RE: Boyce Street Mixed-Use Development
101 West Boyce Street, Manor, TX, 78653
Permit No.: 2024-P-1645-SP
SWE Project No. 1168-001-24

RE: Boyce Street Mixed-Use Development (2024-P-1645-SP)
101, 104, 107 & 108 West Boyce Street, Manor, TX 78653
Detention Waiver Request Letter
SWE Project No. 1168-001-24

DETENTION WAIVER SUBMITTAL PACKAGE FOR BOYCE STREET MIXED-USE DEVELOPMENT

STORM LINE 'A' PLAN & PROFILE
BOYCE STREET MIXED-USE DEVELOPMENT
 101, 104, 107 & 108 W BOYCE STREET, MANOR, TEXAS, 78653

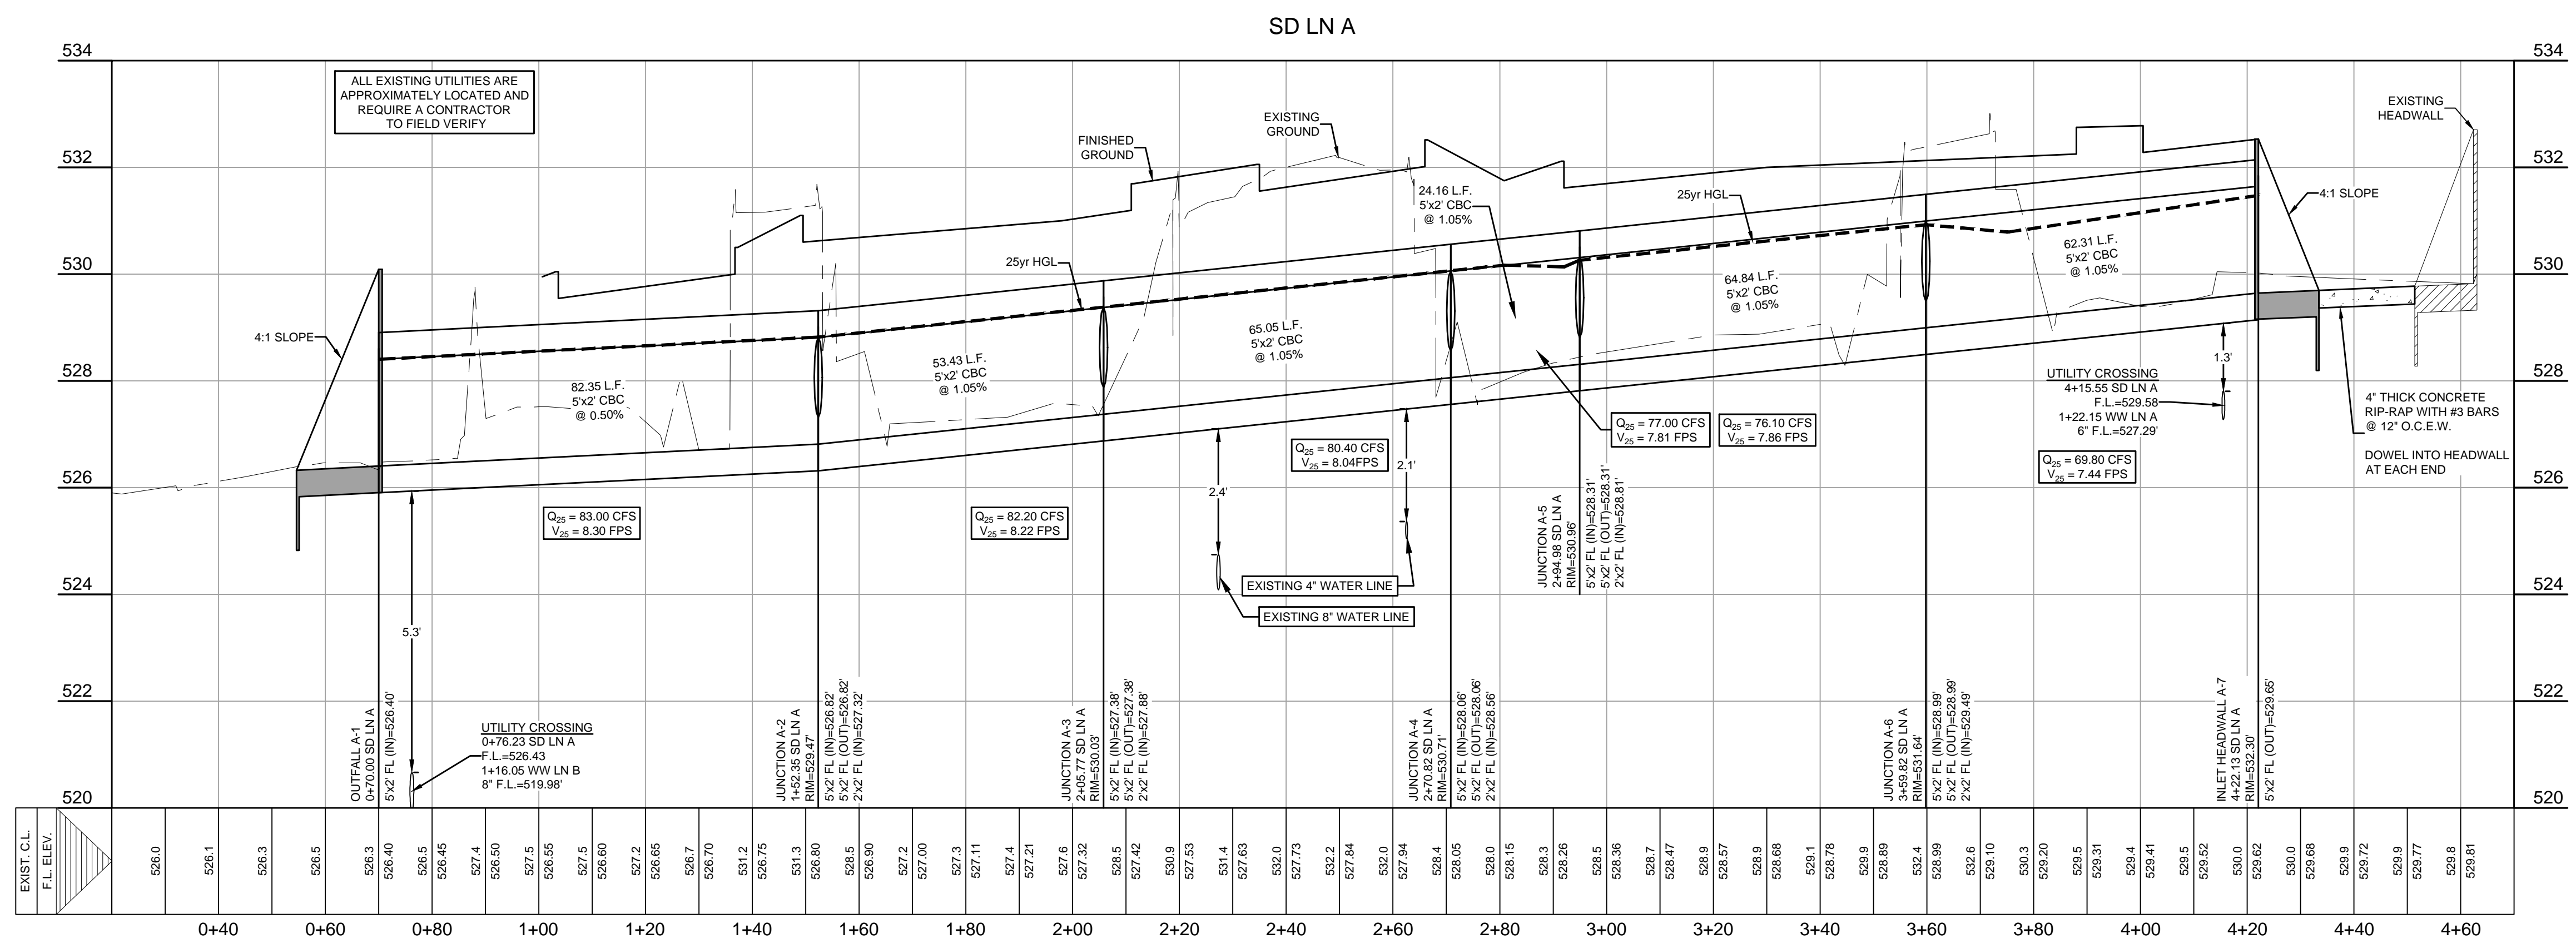
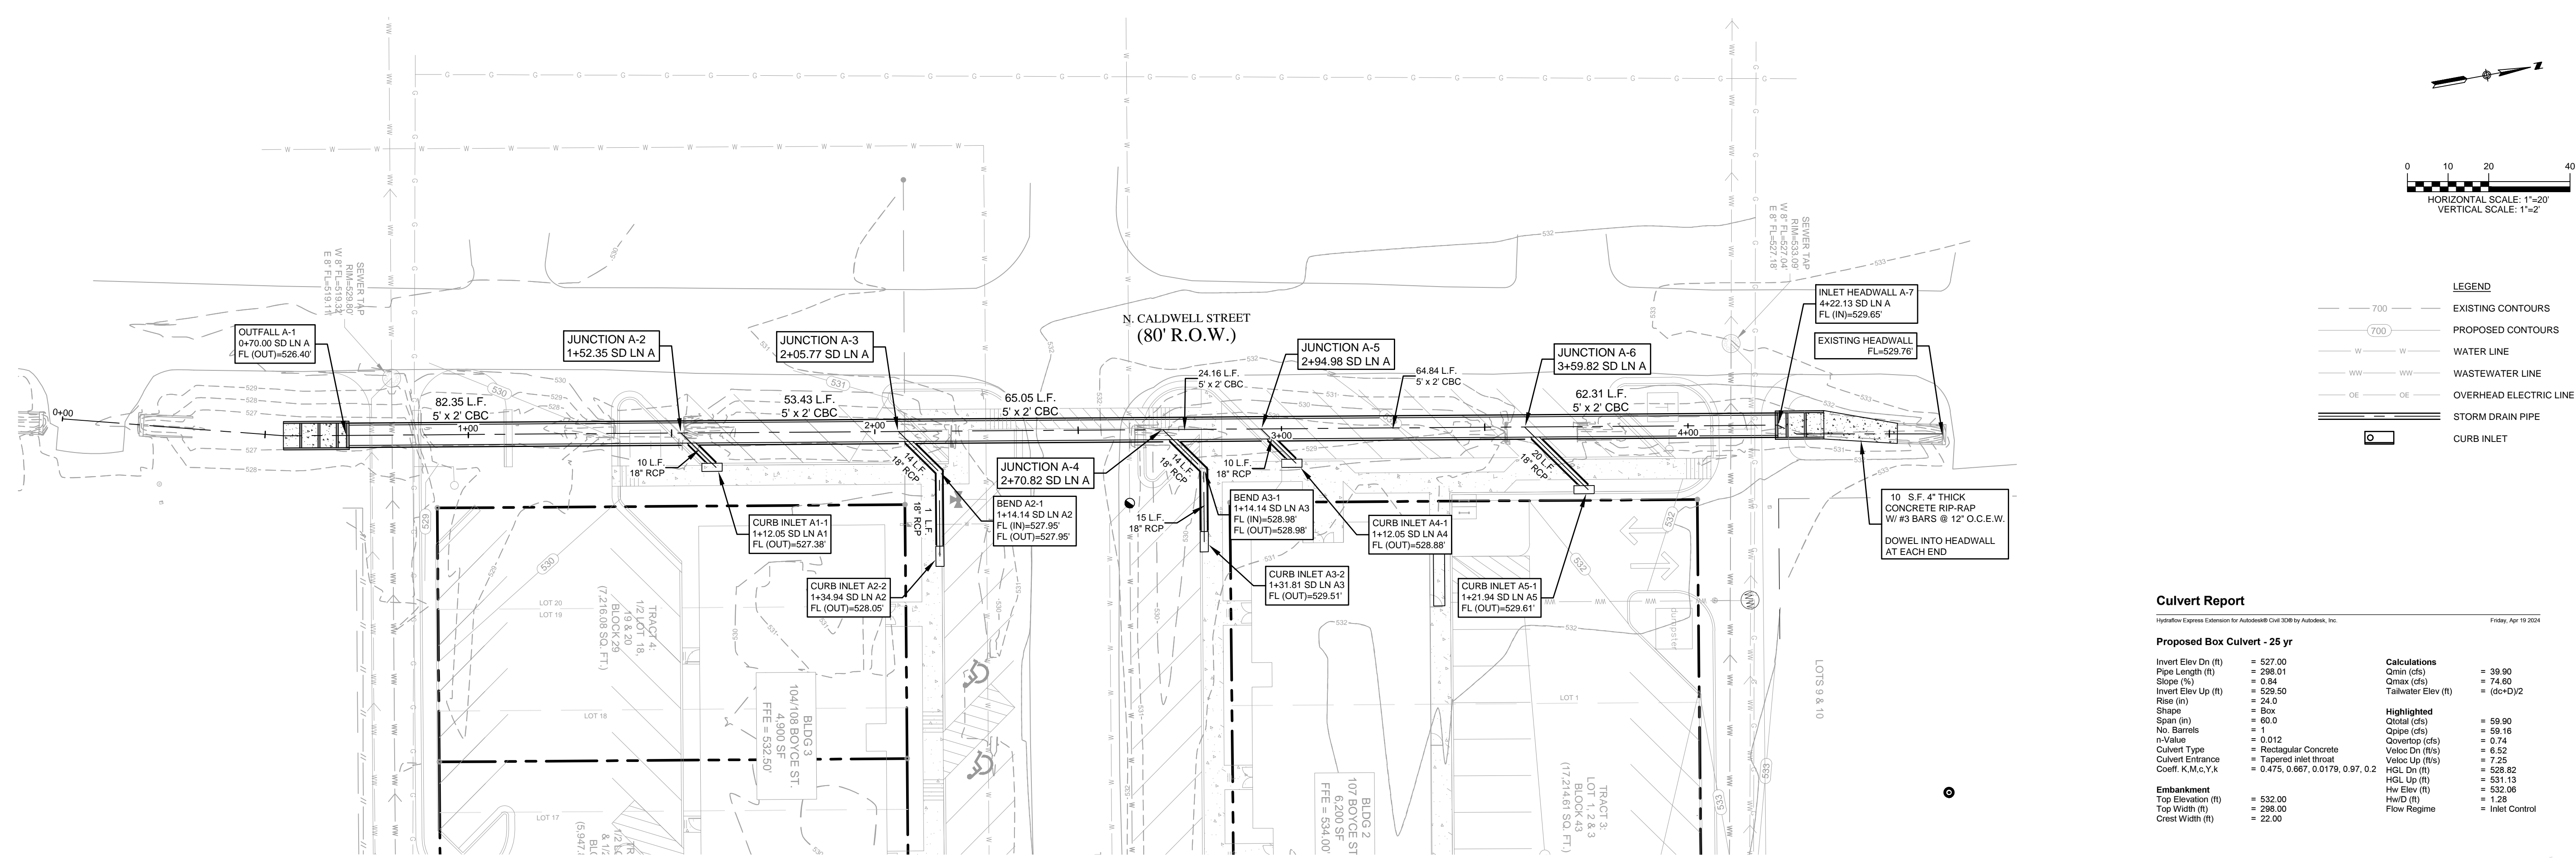
9. All proposed storm drains that will be in the ROW or in a public drainage easement must meet DCM 5.2.0 design guidelines. The design guidelines rules shall be observed in the design of storm drain systems located in public right-of-way or public drainage easements to promote proper operation of these systems and to minimize maintenance requirements. The material and diameter of all public storm drains should be noted on the grading and drainage plan sheets. See DCM 5.2.0.J and DCM 5.3.3. If so, please provide plan and profile for this culvert/storm sewer system and a H&H model to justify the size and capacity. For Storm Sewer design.

- a. Comment remains until all comments are cleared. Correct downstream elevation in printouts, make sure the profile matches the profile (invert El. 526.4). On profile for SD LN A, show grading from 0+70 to 1+00 (+/-). Is the 100-yr HGL contained the ROW? Did you model the SS line? Which model did you use?

Comment Response: The storm sewer design has been updated, plan and profile for the culvert and storm sewer is provided with this update submittal.
